Before an Independent Commissioner
Appointed by the Selwyn District Council

In the matter of Private Plan Change 62 to the Selwyn District Plan

Evidence of Andrew David Carr

31 August 2020

Figure 1: Key Geometry of Potential Roundabout at High Street / Clausen Avenue / Site Access Intersection

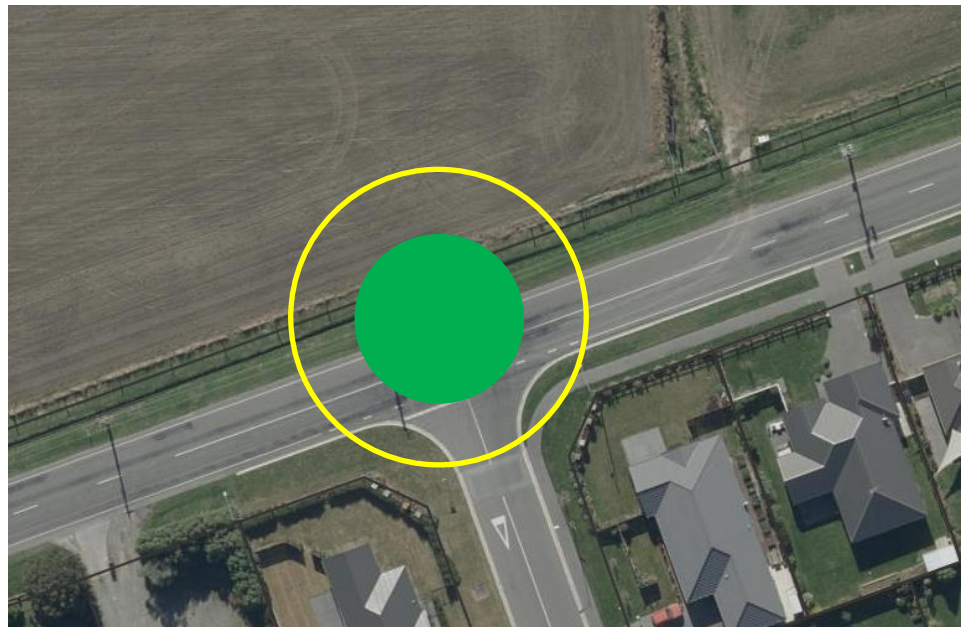
- 51 More importantly, I anticipate that any roundabout would need to be designed to meet current standards. If the current western approach to the potential roundabout was to be maintained at a 100km/h speed limit (as at present), or even reduced to 80km/h, then this means the **minimum** diameter of the roundabout central island would be 20m, and to allow for the movement of heavy vehicles (stock trucks and the like), the circulating carriageway would need to be 8m (Austroads Guide to Road Design Part 8: Roundabouts, Tables 4.1 and 4.3). The roundabout therefore would be around 36m wide (a 20m inner island with an 8m circulating carriageway around it). I have superimposed these key parameters over the location of the intersection, without requiring third party land (and reducing the existing 5m separation between the edge of the carriageway and private land to just 3m, accommodate a footpath and verge).

- 52 It can be seen that the roundabout is located to the north of the centreline of High Street. In turn, this means that the eastern and western approach roads need to be realigned slightly to accommodate the offset.

Figure 2: (Highly) Indicative Roundabout at High Street / Clausen Avenue / Site Access Intersection

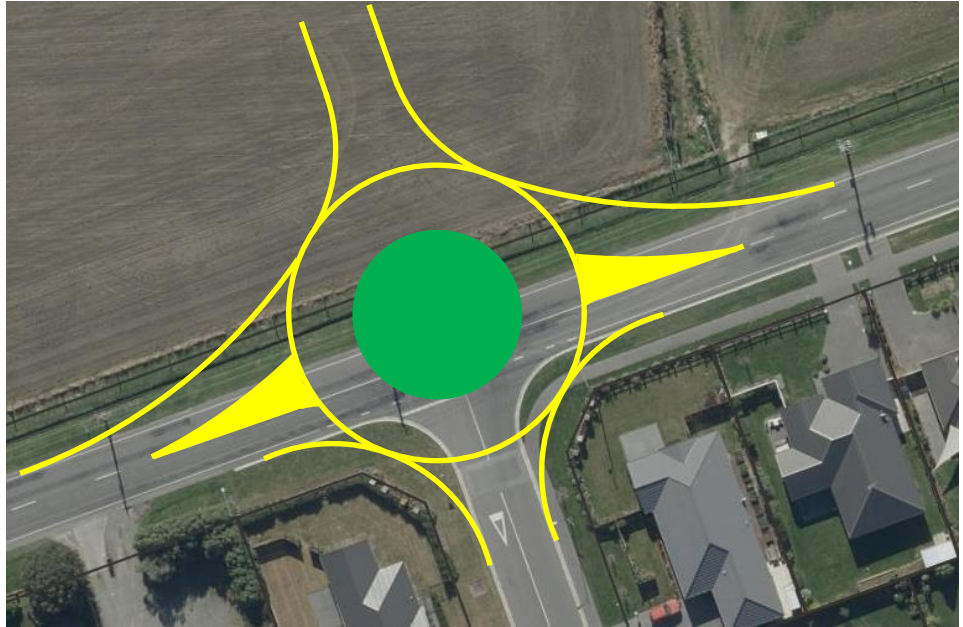
- 53 In my view, this is an unnecessary design solution for what is in essence a lightly-trafficked environment (even with the plan change area fully developed). Even the conservative layout shown above is required to utilise land that is within the plan change area, and would also make access difficult for any lots close to the roundabout and those living on the southeastern and southwestern quadrants. It would also sterilise land within the plan change area that could otherwise be used for housing.

- 54 I note that Mr Mazey sets out that the splays on Clausen Avenue facilitate a roundabout (his paragraph 29). While I agree that they partially assist, the splays are not sufficiently large to eliminate the offset of the roundabout from High Street. Rather, to eliminate the offset would require a smaller roundabout, but in turn, this results in a layout that would not comply with the overarching design guide.
